RISO, INC. **PARTS CHANGE INFORMATION**

PART: HOLDER II; V TRANSPORT ROLLER **ISSUE #: 043**

NEW PART NUMBER: 011-14437 NEW DESCRIPTION: HOLDER II; V TRANSPORT ROLLER OLD PART NUMBER: OLD DESCRIPTION:	[ ] New [X] Modified [ ] Obsolete [ ] Other
Compatible: [X] Not Compatible: [ ] Old/Obsolete: [N]

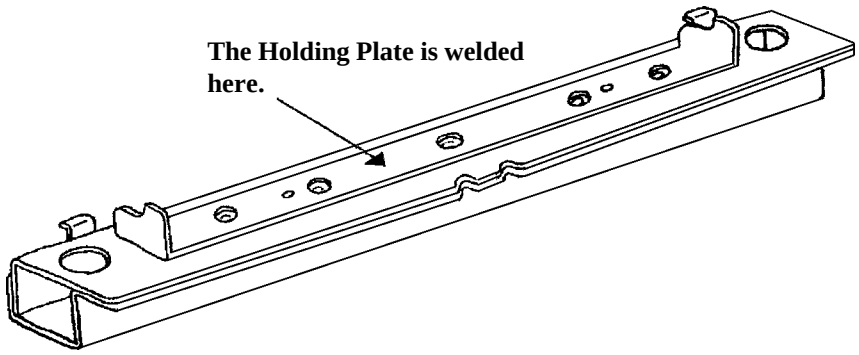
To prevent the Vertical Transport Roller from lifting when the new Transport Gears are installed (PCI-019), an extra plate has been welded to the Vertical Transport Roller holder.
